OREGON CITY PLANNING COMMISSION

Type IV - Annexation with Zone Change –Park Place
Planning Commission April 9, 2018

Subject: PA-16-57: Park Place 91 Acre Annexation & Zone Change

Response to Land Use Application AN 17-04

Figure 1 - Functional Classification Map from Park Place Concept Plan

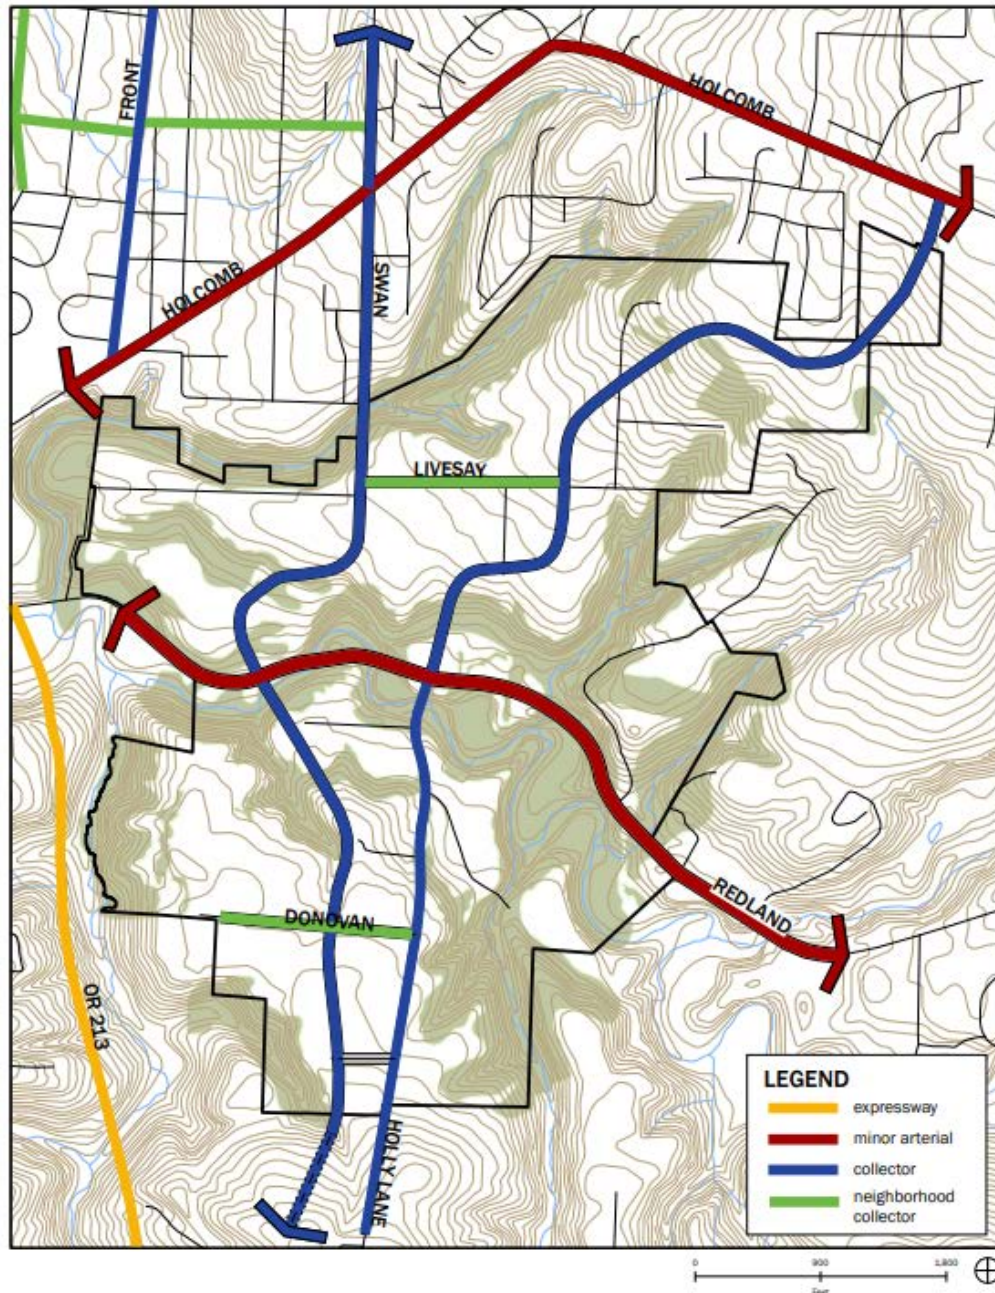
The intent of development in the annexation area is not to rely on Livesay Road west of the project site. The roadway is generally narrow and unimproved. For this reason, the original TIS did not assign trips to the roadway or rely on it for access. The Park Place Concept Plan considers a functional upgrade to Livesay Road to a Neighborhood Collector classification between the planned Swan Avenue and Holly Lane extensions. This is shown in Figure 1 below, which is the Functional Classification Map from the Concept Plan. Consistent with the Concept Plan, development on the site is intended to rely on streets other than Livesay Road.

For these reasons, the evaluation of the intersection of Livesay Road and Redland Road is not necessary at this time. Rather, impacts to Livesay Road should be carefully examined and minimized as development occurs through the Master Plan process.
